Model: Paper Feed Unit for Model Ti-P1		Date: 05-Sep-13	No.: RM406001
Subject: Upper Left Cover & Frame		Prepared by: H.K.	
From: 3rd Tech Service Sect., MFP/P Tech Service Dept.			
Classification:	<input type="checkbox"/> Troubleshooting <input type="checkbox"/> Mechanical <input type="checkbox"/> Paper path <input type="checkbox"/> Product Safety	<input checked="" type="checkbox"/> Part information <input type="checkbox"/> Electrical <input type="checkbox"/> Transmit/receive <input type="checkbox"/> Other ()	<input type="checkbox"/> Action required <input type="checkbox"/> Service manual revision <input type="checkbox"/> Retrofit information <input type="checkbox"/> Tier 2

Model: Paper Feed Unit for Model Ti-P1		Date: 18-Oct-13	No.: RM406002
Subject: RUBBER FOOT		Prepared by: H.K.	
From: 3rd Tech Service Sect., MFP/P Tech Service Dept.			
Classification:	<input type="checkbox"/> Troubleshooting <input type="checkbox"/> Mechanical <input type="checkbox"/> Paper path <input type="checkbox"/> Product Safety	<input checked="" type="checkbox"/> Part information <input type="checkbox"/> Electrical <input type="checkbox"/> Transmit/receive <input type="checkbox"/> Other ()	<input type=

Left upper cover:

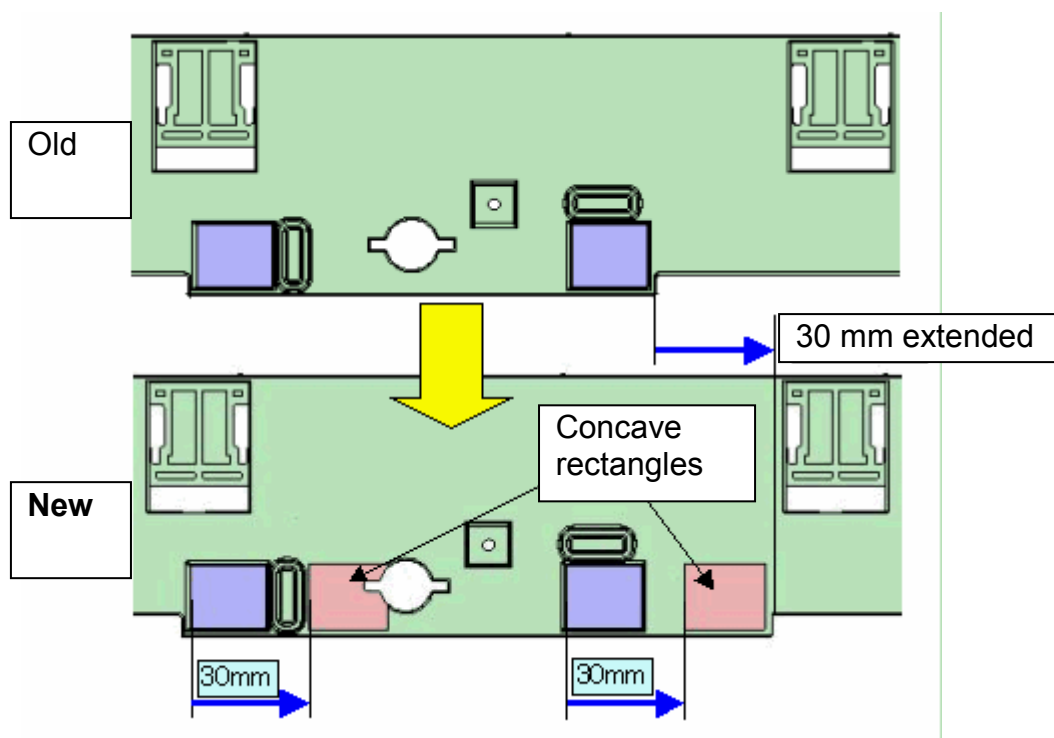
Change: The shapes of the left upper cover and left side frame (non service parts) were changed.

1. The two concave rectangles were added.
2. The length of the cover was increased by 30 mm.

Left side frame

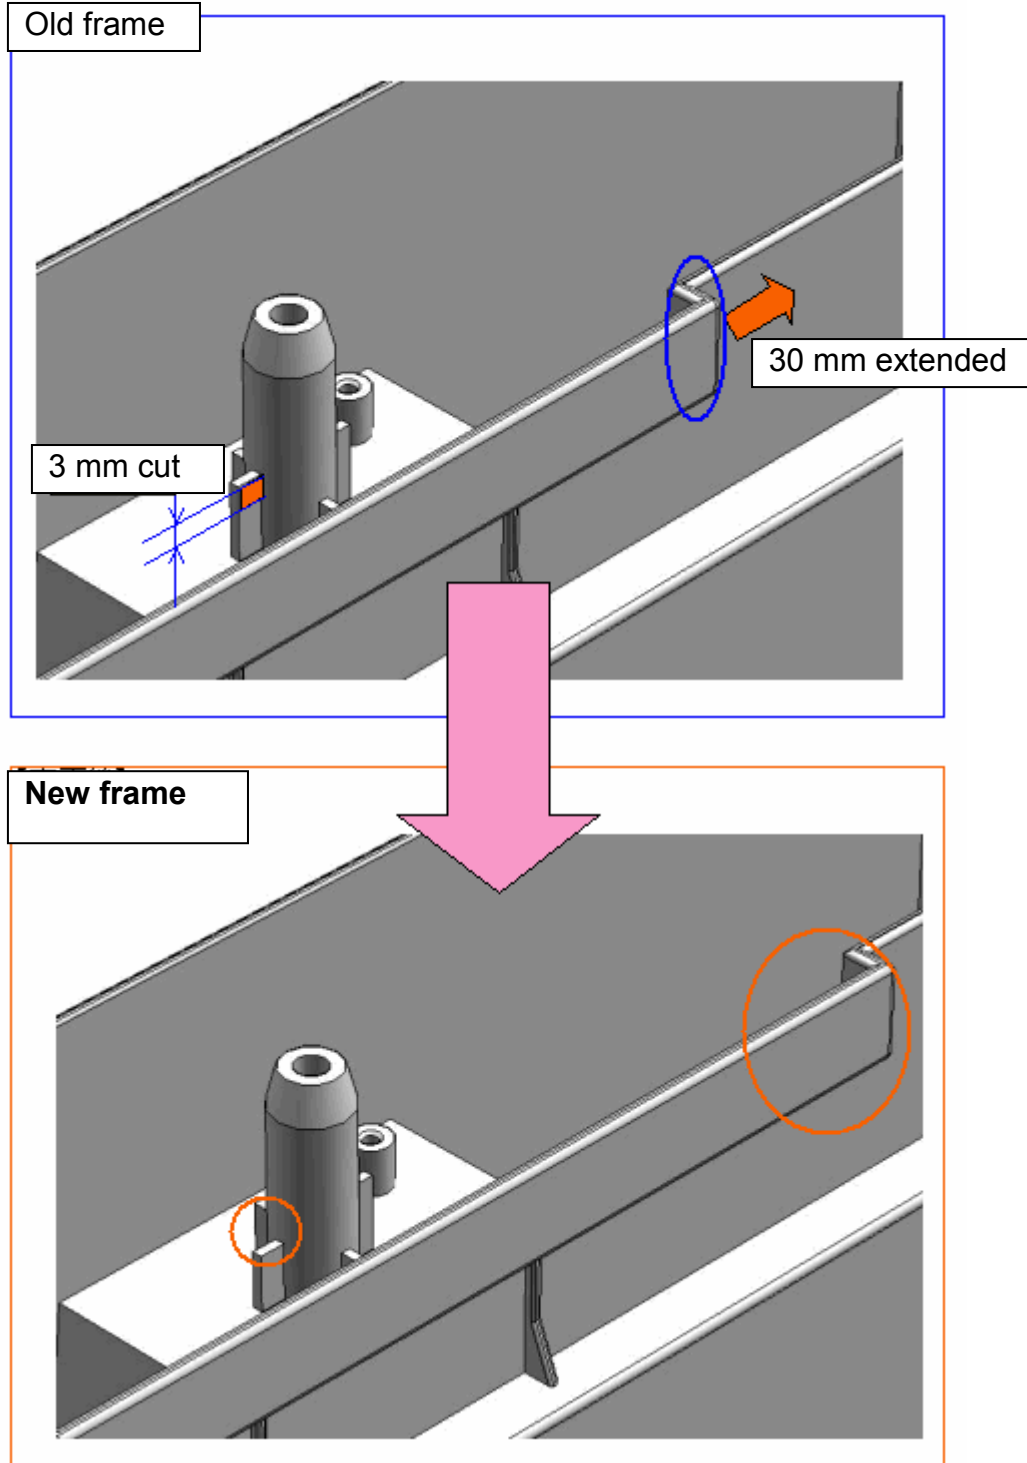
1. A 3 mm section was cut from the area of the rib shown.
2. The length of the frame was increased by 30 mm.

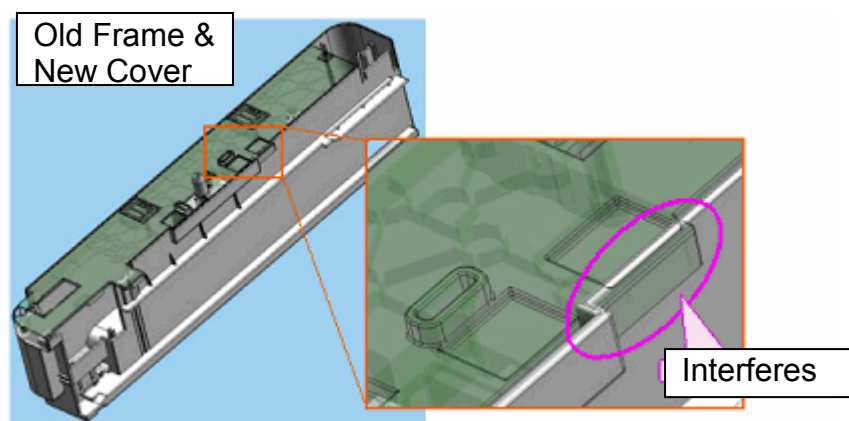
- Interchangeability of production machines:
 - M4061003 → M4081003 = X/X
- Interchangeability of old machines in the field:
 - M4061003 → M4069500 = O/O
- The M4081003 cover cannot be installed on old machines in the field due to physical incompatibility with the new frame.
 - M4081003: For attachment to new machines in the field
 - M4061003 and M4069500: For attachment on old machines in the field.

Note: M4069500 has been specially modified so that it is compatible with the frame on old machines.

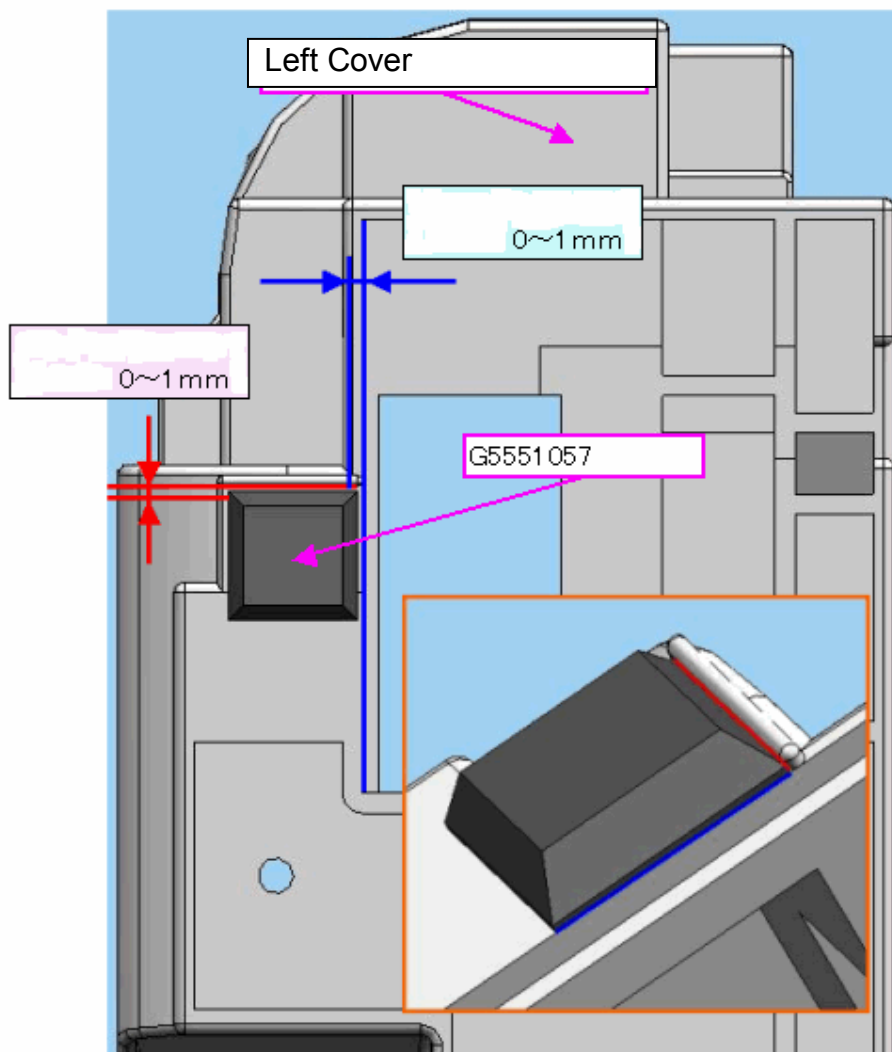
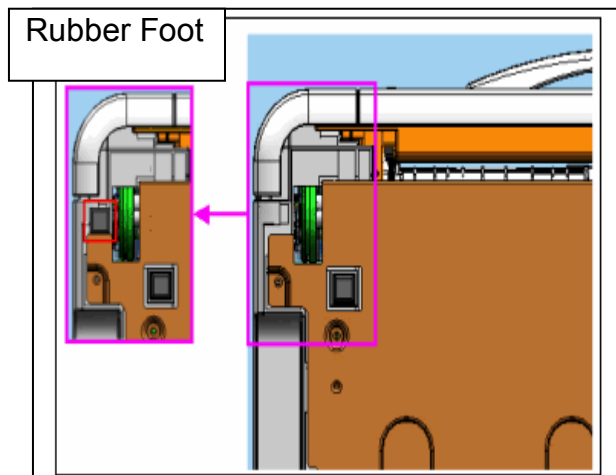
Change: The quantity for this part was increased from 2 to 3.

Reason: To further improve the stability of the tray when placed on a desk or table.

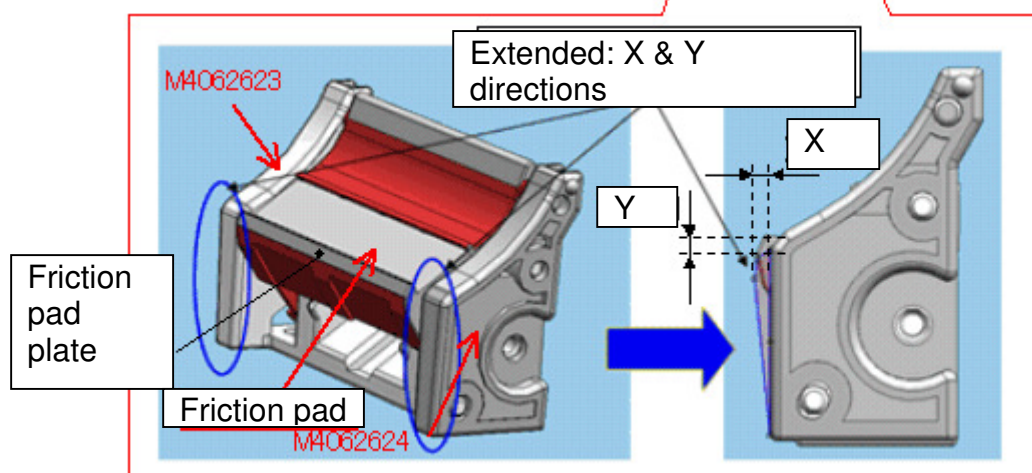
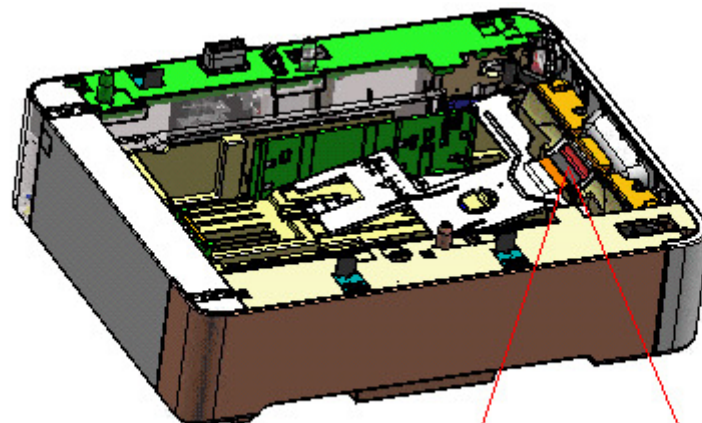
The friction between sheets of paper is high, causing one or more extra sheets to be fed together with the top sheet. The sheets hit the friction pad plate, and the plate lowers. As a result, the top sheet is held in place by the plate and is not fed.

The shapes of the friction pad holder and cover were changed.

1. This modification enables the holder and cover to stop ***the friction pad plate from lowering. (Modification 1)***
2. ***The paper tray holder sheet was eliminated on the modified machines since it was no longer necessary to prevent non-feed jams, but it is still available as a Service part for older machines. (Modification 2)***

IMPORTANT: If you need to replace the old friction pad holder or cover in the field, make sure to install the new parts **together as a set**.

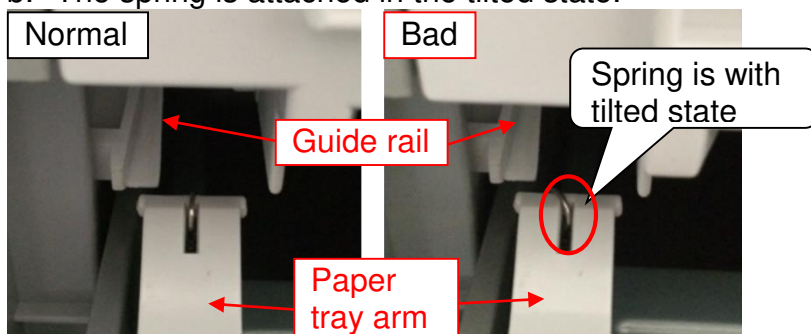
a. The operator inserts the paper feed tray with one side tilted (see the photo).

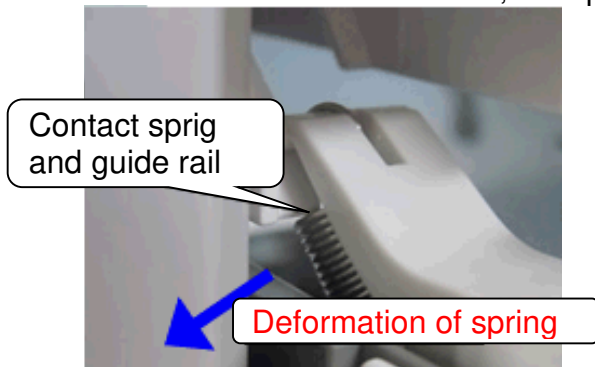
b. The spring is attached in the tilted state.

As a result of the above state, the spring contacts the guide rail and is deformed.

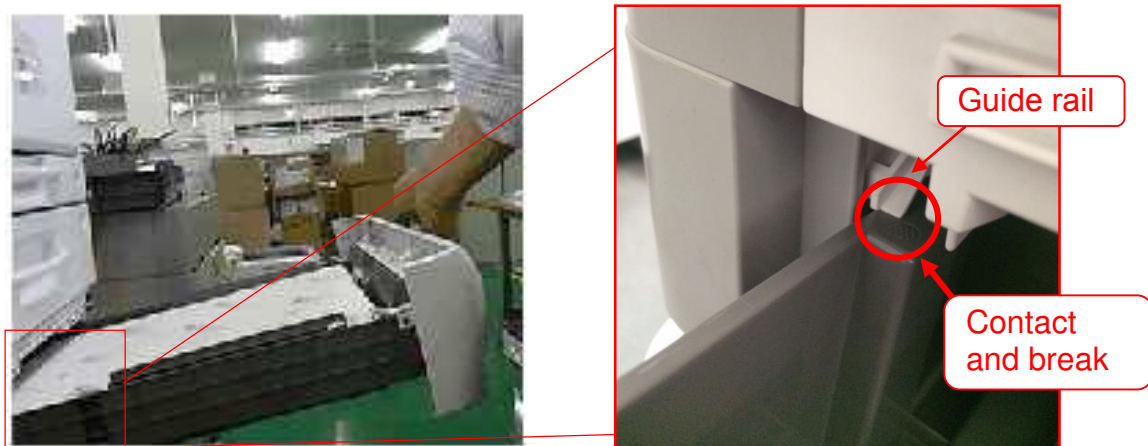
The operator lifts up the paper tray (see the photos) when pulling out the tray. This causes the guide rail to be broken by contact with the tray (see the photos). As a result, the paper tray base plate cannot lift up to the position of the paper.

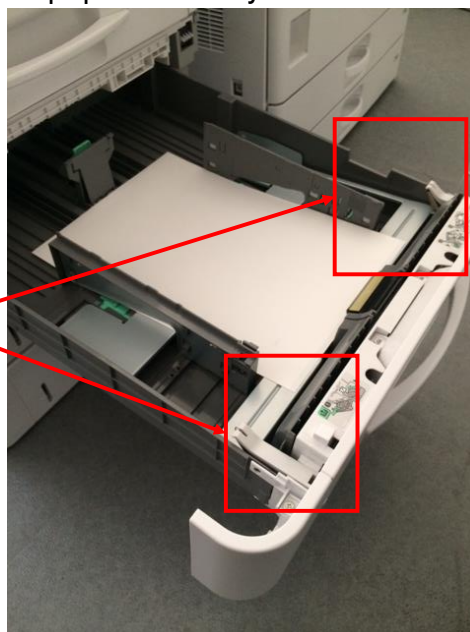
The new part was added to the additional paper feed tray as shown.

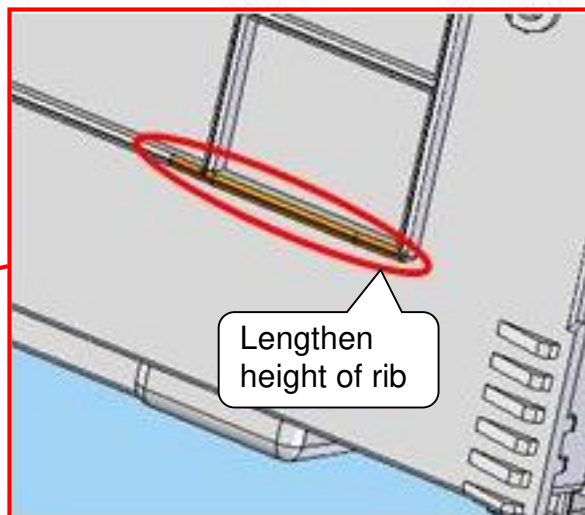
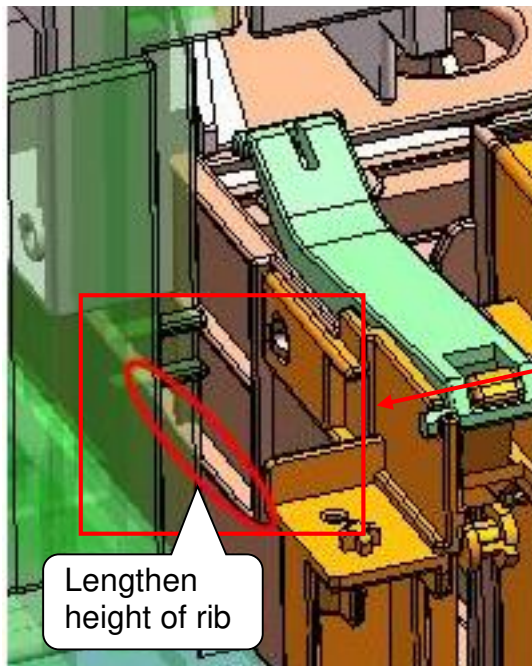
1. The height of the rib (see the photo) was increased on both sides.

Note: This is to prevent contact between the spring and guiderail. The lengthening of these ribs minimizes the rattling of the tray.

2. The guide rail was strengthened

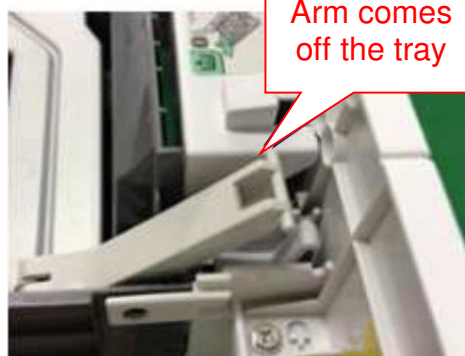
The paper tray arm detaches easily.

Modification position

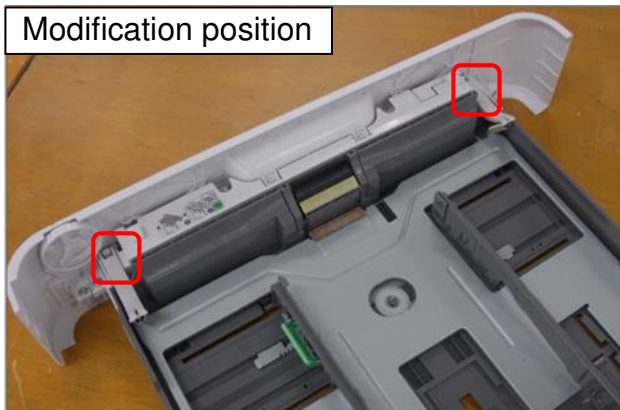
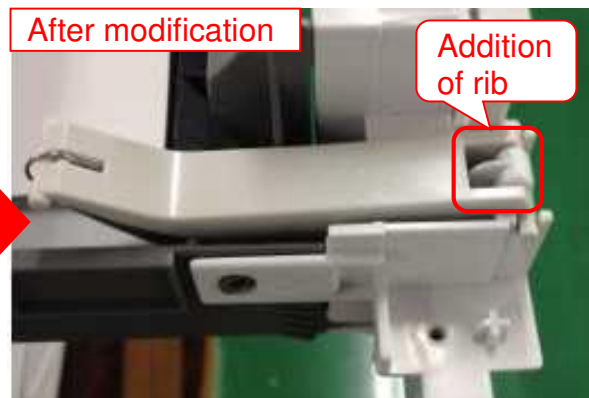
Two ribs were added to the additional paper feed tray.

Note: This is to prevent the paper tray arm from detaching easily.
